3.12 CASK HANDLING

Re: Turkey Point Units 3 & 4  
Docket Nos. 50-250, 50-251  
Fuel Assembly Decay Time

SAFETY ANALYSIS: FUEL SHIPMENT <120 DAYS

FIG. 2.29. Decay power as function of time after shutdown

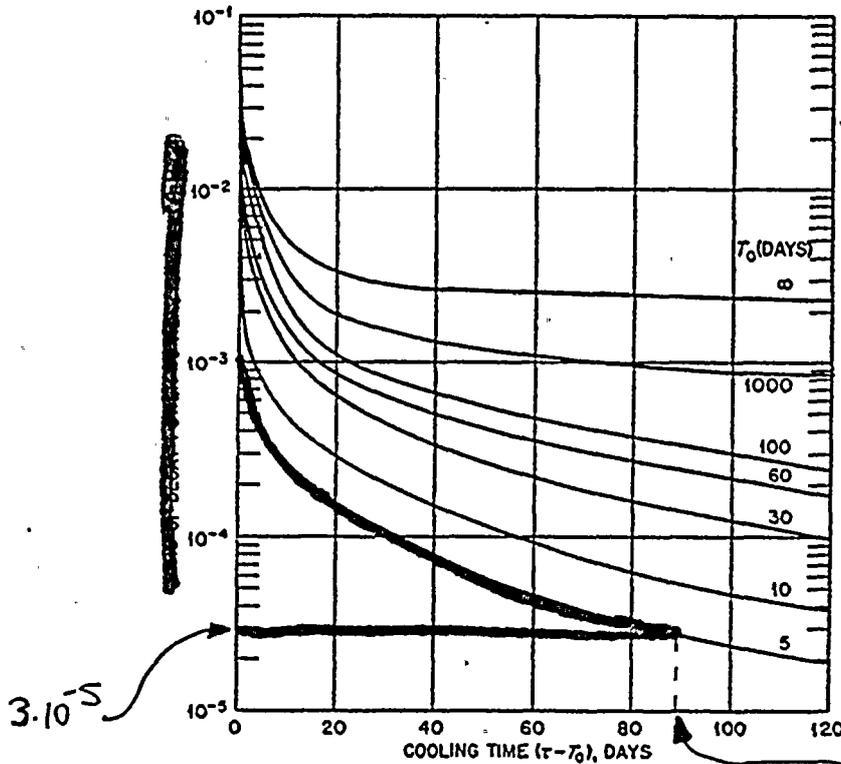
$3 \cdot 10^{-5}$

90 DAYS

7-23-81
